RE: MA APS Draft Comments

6/30/16

Massachusetts DOER,

Figure 9. Metering Diagram for a Large, VRF ASHP

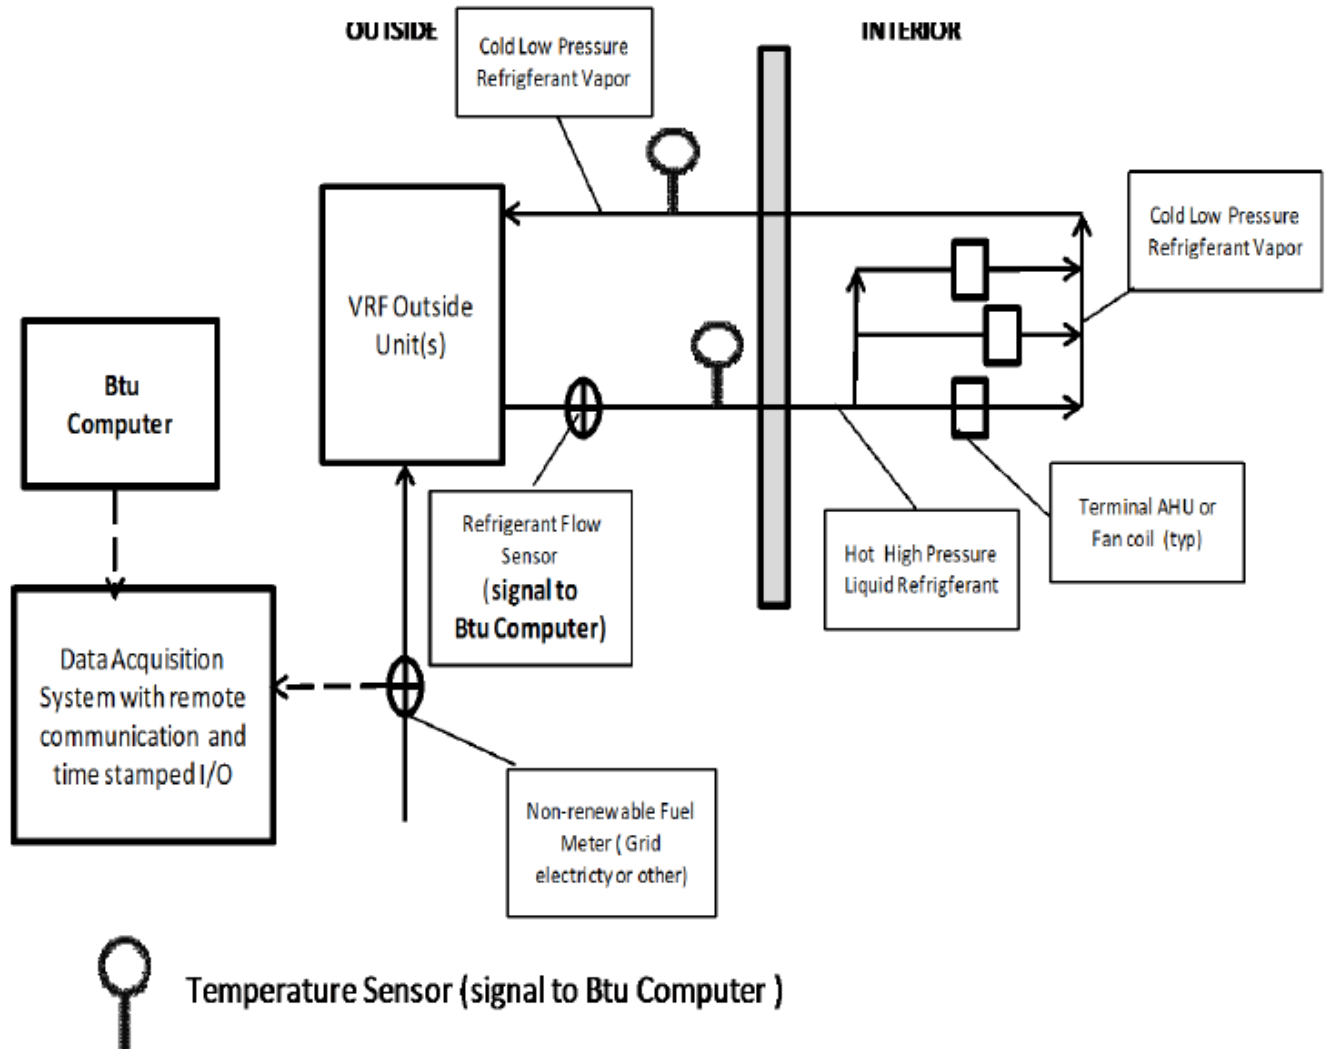
Refrigerant mass flow measurements in the field would be a difficult and costly endeavor. To get the desired accuracy, the cost of the flow meter, transmitter, and data acquisition hardware would likely be in the range of \$12,000 to \$15,000 per refrigerant system. The flow meter must be installed in the refrigerant circuit in a location where there is certain to be only single-phase refrigerant. Any chance of two-phase refrigerant will produce inaccurate and unreliable results. The presence of the flow meter in the refrigerant circuit can be a restriction, especially if improperly sized, and the resulting pressure drop will affect the performance of the system. The addition of a flow meter introduces new potential leak points in the refrigerant circuit. The flow meter and transmitter may be large and bulky, making them less than suitable for field installations.

Appendix B shows the refrigerant mass flow measurement diagram and corresponding formula for calculating AEC's for large VRF ASHP RTGU's, while Appendix C show the airflow/delta T diagram and corresponding formula for large DX ASHP RTGU's.

Due to the complexities and potential downsides to system performance of mass flow measurement in the field, we would recommend the use of condenser airflow and delta T measurements for VRF systems for alignment and better comparison to conventional heat pumps. Given the variable nature of VRF condenser fans, there is potential to measure input power to the condenser fan for use as a proxy for airflow (would need to be calibrated in the field).
